**RE: Amendment to Modification Requested July 24, 2012
Piney Hill Acres LCID Landfill/Treatment and
Processing Operation Plan
2020 Piney Grove Road, Kernersville, North Carolina
NC Solid Waste Permit No. 34-AA**

Enclosure: Figure 2 LCID Landfill Existing Contours

FIGURE 2
LCID LANDFILL EXISTING CONTOURS

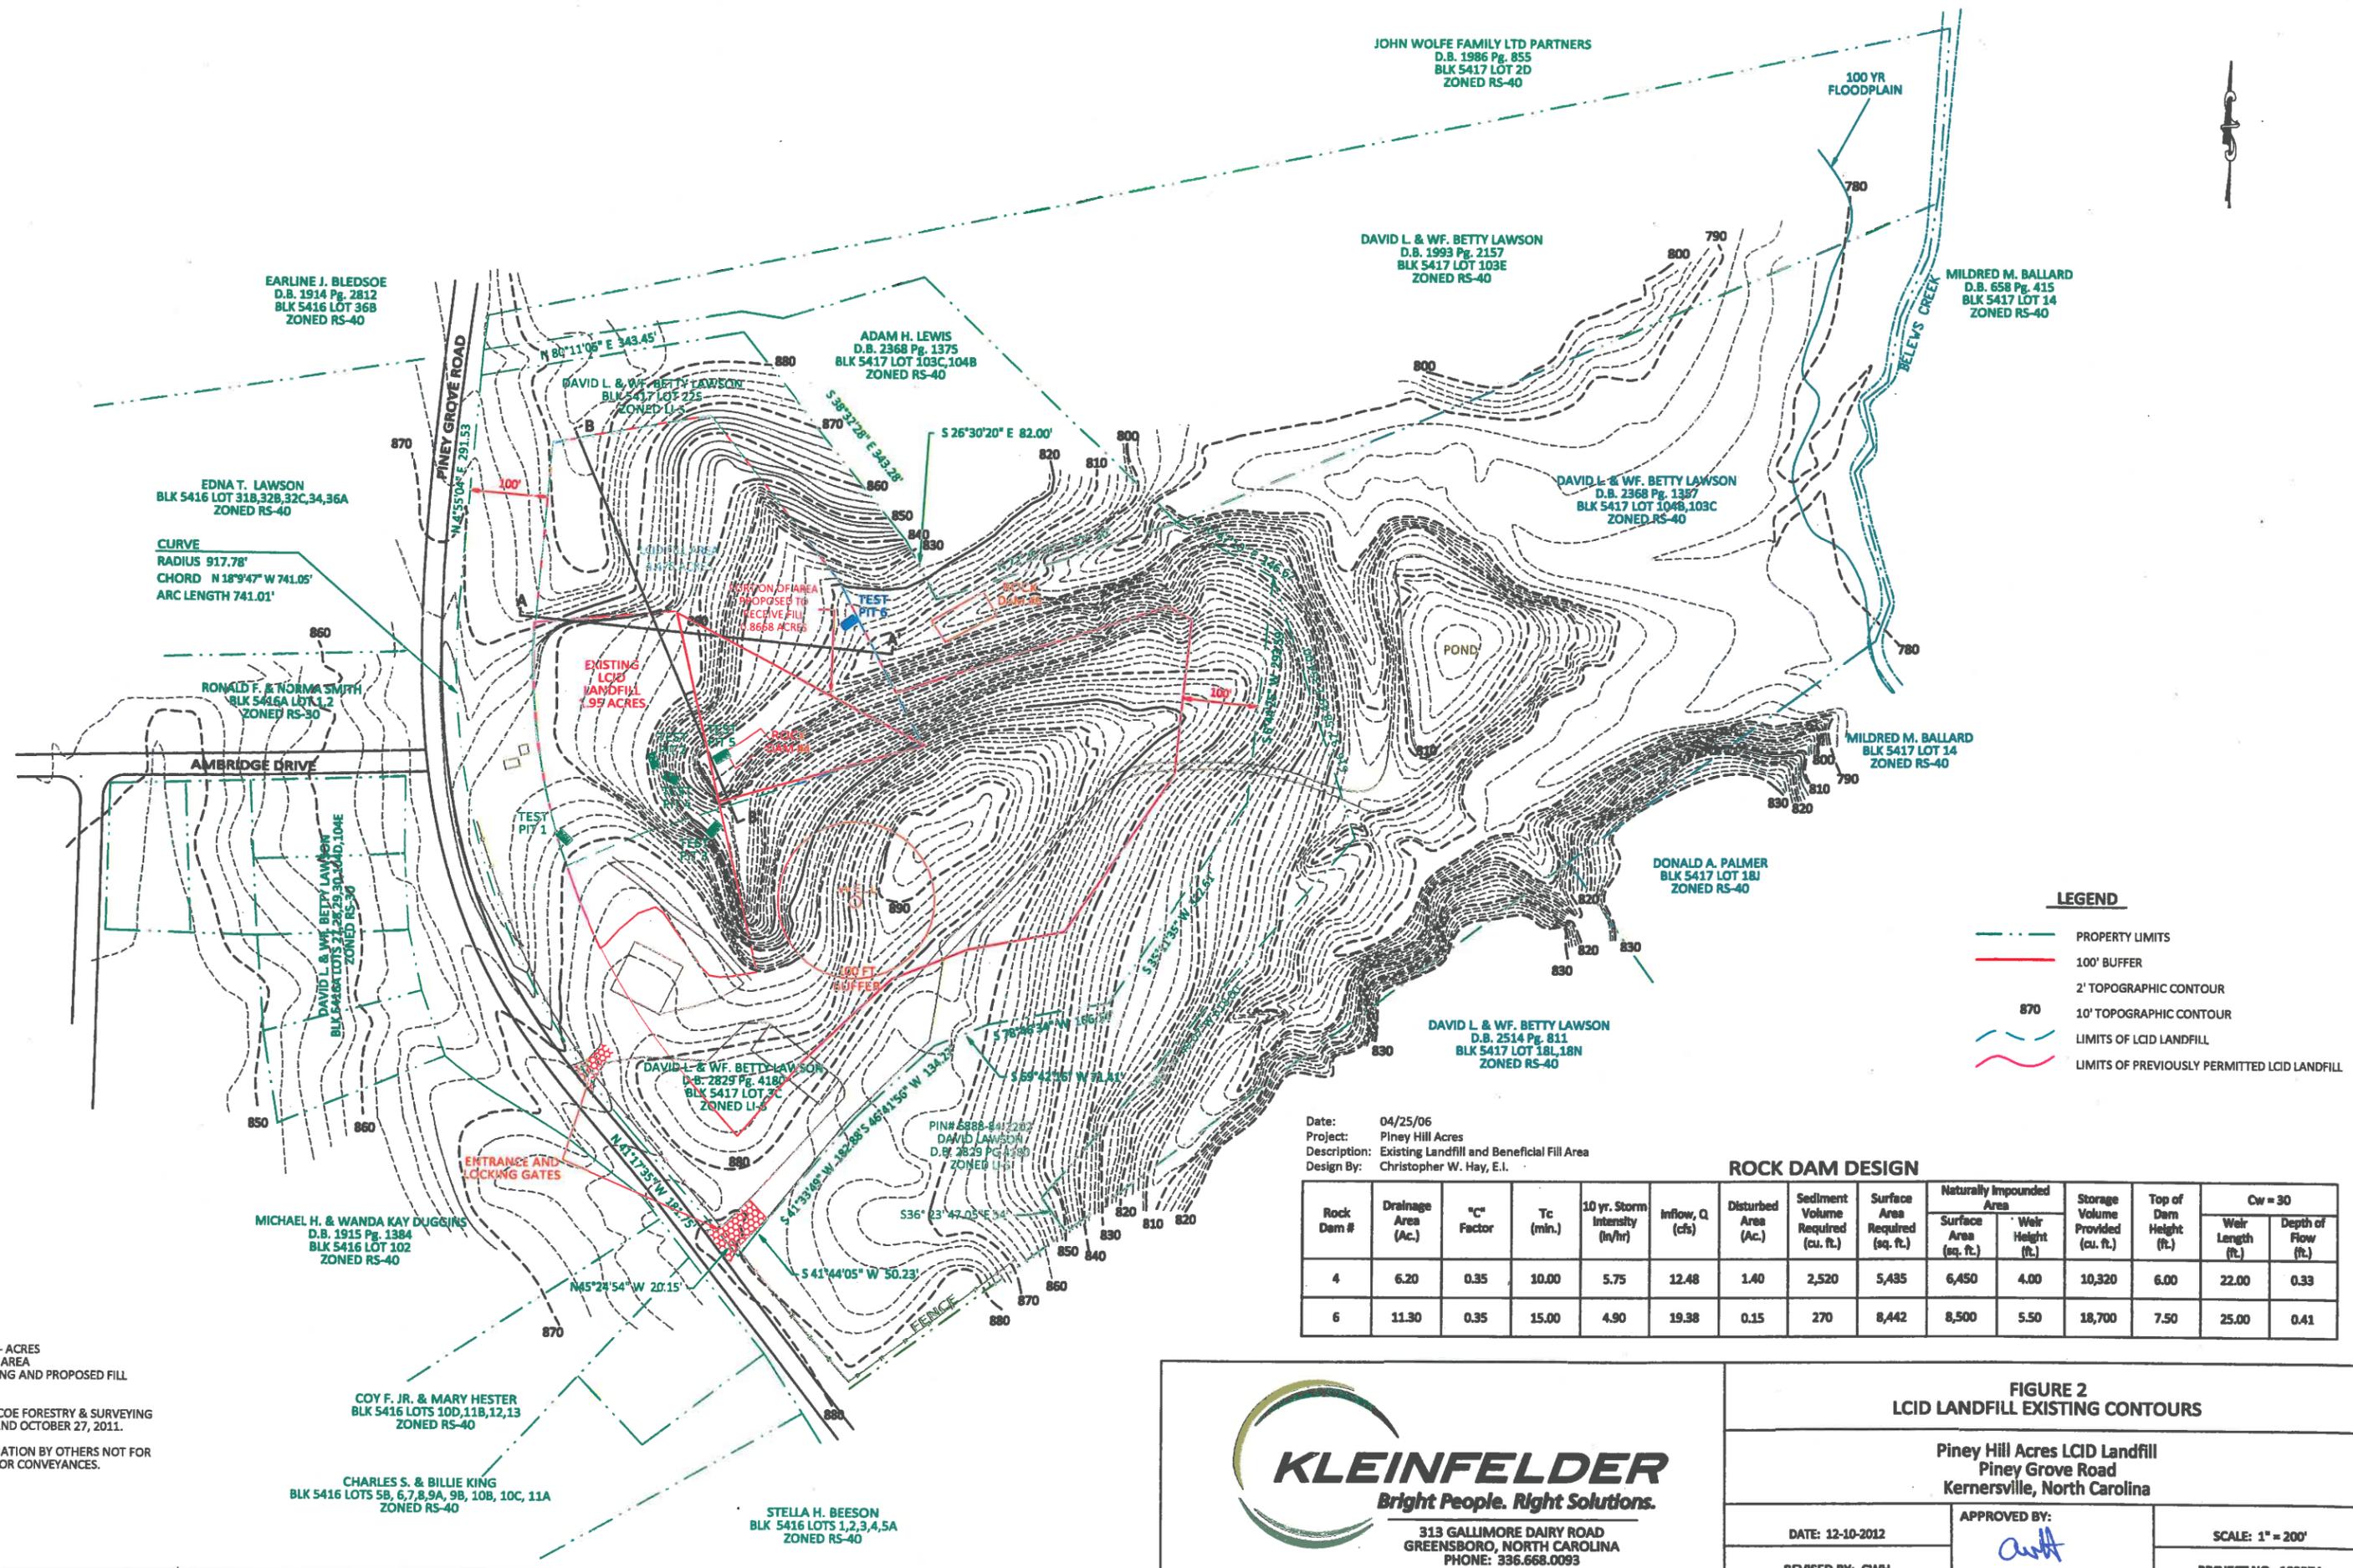
Kleinfelder Southeast, Inc. is submitting an updated Figure 2, as requested, for the referenced land clearing and inert debris landfill/treatment and processing facility. Additional to the requested modification of the permit dated July 24, 2012, the landfill owner/operator requests approval to begin placing fill outside the existing LCID landfill (1.95 acres) in a portion of additional area permitted (4.475 acres). This will allow operations to continue on the existing fill slope and provide additional area for fill. The existing LCID landfill is nearly filled to final elevations.

Kleinfelder visited the LCID landfill on November 13, 2012 with the owner/operator to review existing conditions. The portion of the additional area requested to place fill is shown on Figure 2. The bottom elevation is above the previously permitted bottom elevation and is well above the seasonal high water table. Elevations within the existing LCID landfill and permitted fill area have been updated to represent conditions observed in November 2012. Based on our observations, the LCID landfill continues to be in compliance with submitted and approved plans. No additional modifications are being requested at this time. Should you have any questions or require clarification, please contact Chris Hay at 336.668.0093 or chay@kleinfelder.com.
